4.3 The applicant provided further points of clarity, see Annexure G2 attached, in response to branch comments received. In particular, they ~~wanted to~~ demonstrate their responses to Spatial Planning, Urban Design and Landscaping. Their comment is as follows:

4.4.1 Spatial planning and Urban Design:

Original submission – precinct 1

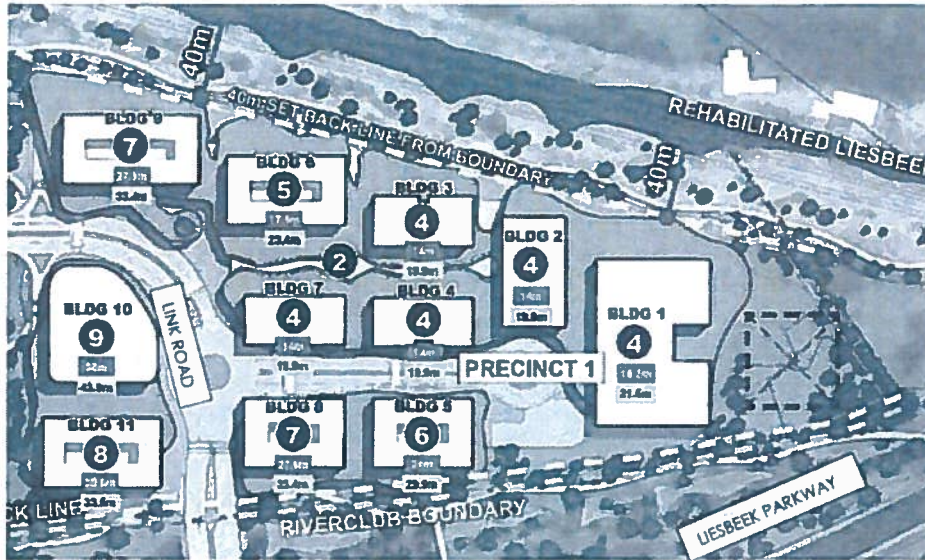
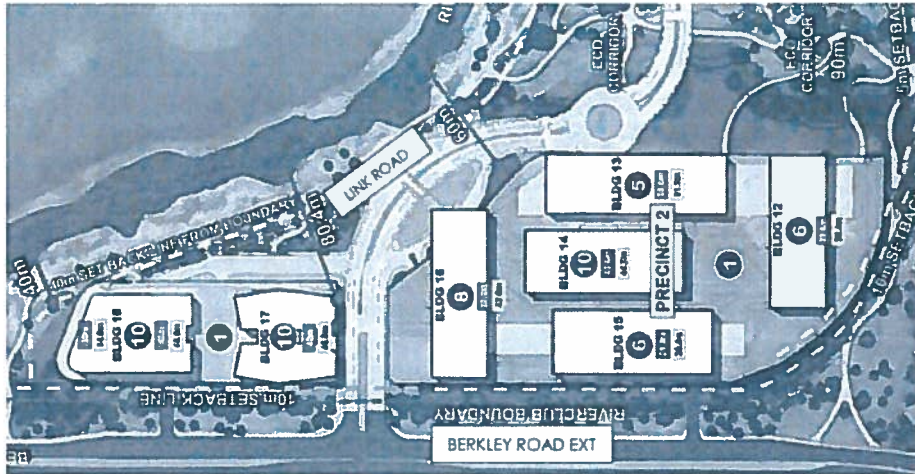
The initial submission suggested a certain built form. After the applicant responded to branch comments received, it was suggested that the built form will largely remain the same with certain aspects that would change.

Building heights toward the SAAO are also proposed to be lowered. Building heights experienced along Liesbeek Parkway are similar to that originally proposed. It will appear that buildings are disaggregated to a greater degree. Planting will be provided between buildings. As the proposal enters the final design stages it is imperative that cognisance is taken of the significance of the SAAO being a national heritage site. Some views to the SAAO may be retained even if through view corridors. These will be addressed at the Precinct Plan stage.

As is evident from the illustrations above, the building massing for precinct 2 has changed from that originally presented. Originally buildings were markedly more disaggregated than that now presented. View lines across the site appear to be somewhat reduced from the original submission. Other design interventions may need to be employed to explore alternate types of massing and form. Whether alternate forms can be explored is uncertain as the applicant has indicated that their desired anchor tenant has largely influenced the change in building massing. While this may be the case, other design interventions could potentially be employed to ensure a better/improved built form.

Provisional Plan of Subdivision

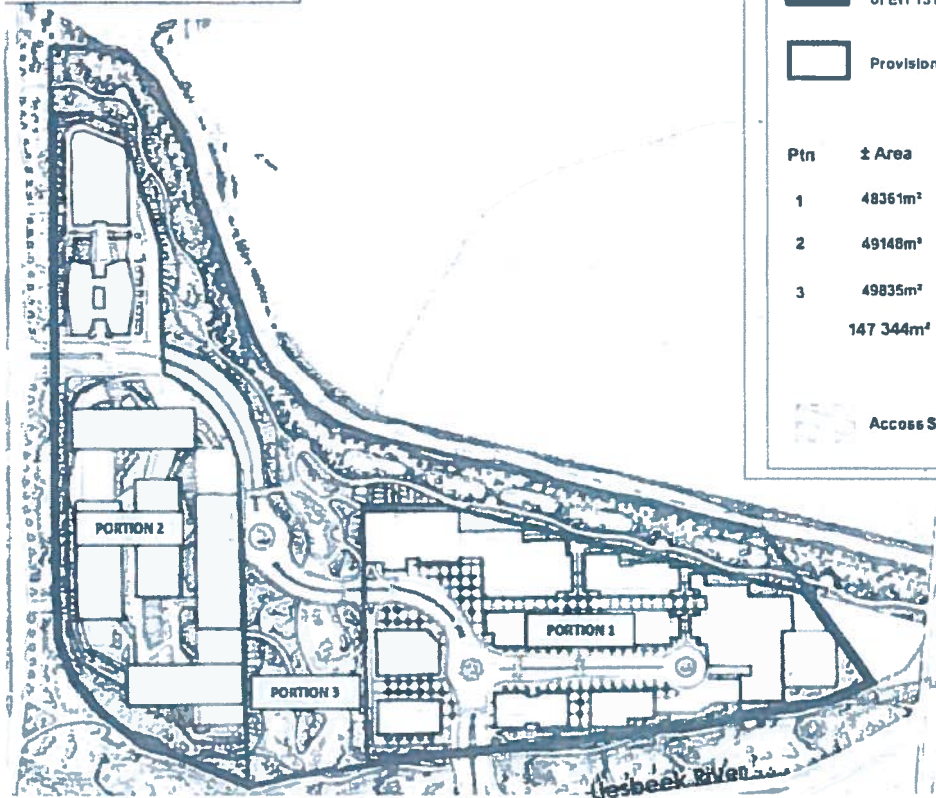
Reference is made to an extent of 109 520m<sup>2</sup> being open space. It is unclear what is being referred to in this instance. It must be noted that the EA issued incorporates components of into the development that extends beyond the property boundary. It is therefore unclear whether the additional extent referred to relates to the property and landscaping elements within the business precincts or whether the addition extent in fact includes City land.

The reduction in the extent of land indicated as being zoned for public open space by almost 1865m<sup>2</sup> is not considered significant. It equates to a variance of less than 1% from that originally indicated, and mentioned previously. The application will be conditioned accordingly to limit the extent of OS3 to the minimum figure indicated above. It must be noted that since the extent of the buffer that must be provided along the old Liesbeek River must be increased, the actual extent of the portion zoned for OS3 may in fact increase.

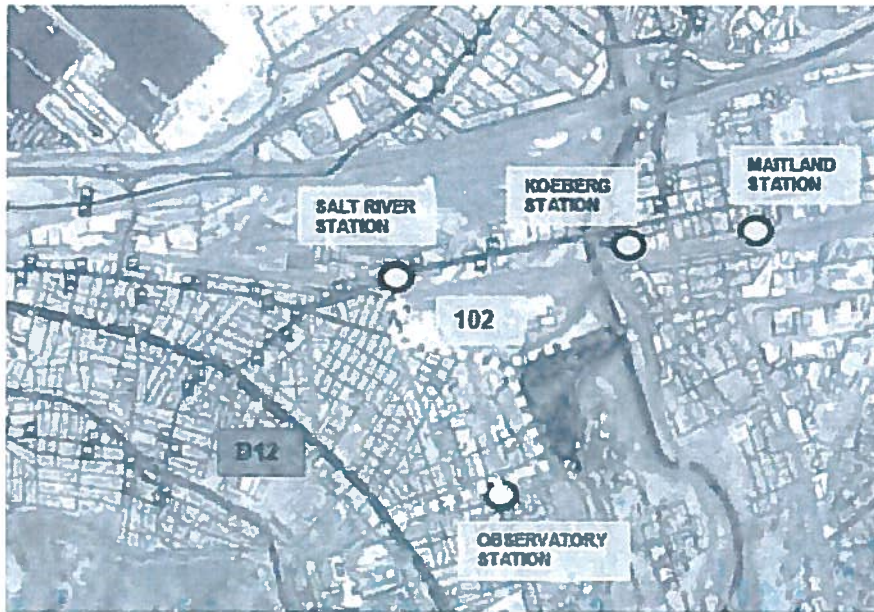
Liesbeek Parkway is not an IRT or BRT route, further there are no plans for it to be established as an IRT or BRT route. These routes have already been determined. The role out of the current IPTN routes is currently underway/in process. Having said this the IPTN is presently under review and consideration may be given to the benefits of developments of this nature. The location of the site within an integration zone, may also serve as impetus to focus attention on improving access of the site and its surrounds to public transport.

Observatory Station and Liesbeek Parkway. It is therefore unclear how the proximity to GABS bus services was determined in the TIA as this service, [according to the City's information and checking on bus timetables] appears to be defunct. The location of GABS routes is therefore much further than the suggested 2 minutes. GABS routes are located along Voortrekker Road and also Canon Road in Maitland and extend along Berkley Road toward Ndabeni Circle and toward Voortrekker from Berkley Road. The shortest walking distances to bus stops are approximately 15mins from the property when heading toward Maitland.

Figure denoting building height from 1<sup>st</sup> habitable floor to the top of roof

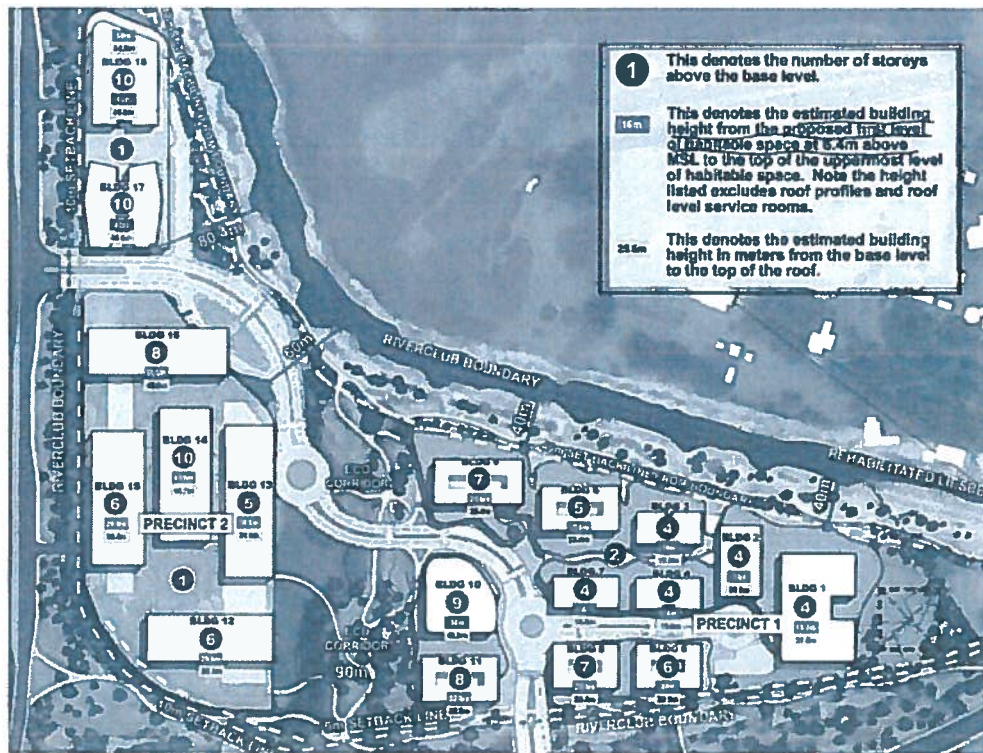
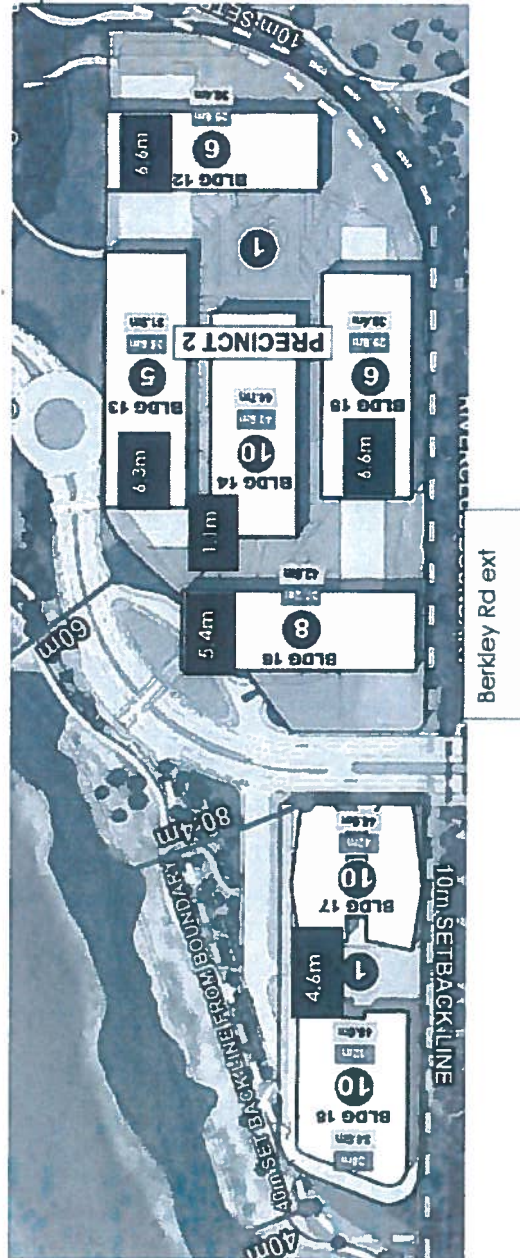
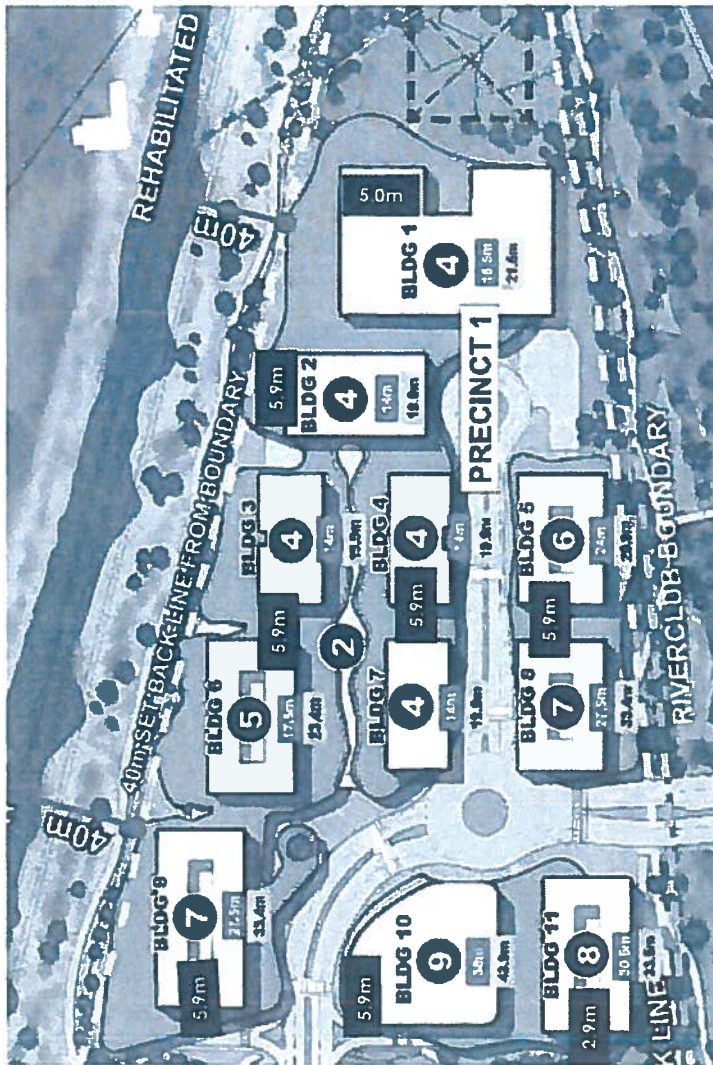
Services will be provided on top of the roof. Heights between highest habitable spaces (i.e. top floor) and roof height vary from 1.1m to 6.6m. (The figure in black illustrating the heights from top of highest habitable floor to top of roof height. Any height exceeding 2.4m enables the opportunity for additional floors to be inserted beyond that proposed.)

It is unclear why such significant differences exist between top of habitable floor and top of roof height. In fact, such a significant difference in height further supports the argument that building heights to top of roof could be lowered. Generous roof heights as proposed supports the argument that building heights can in fact be lowered.
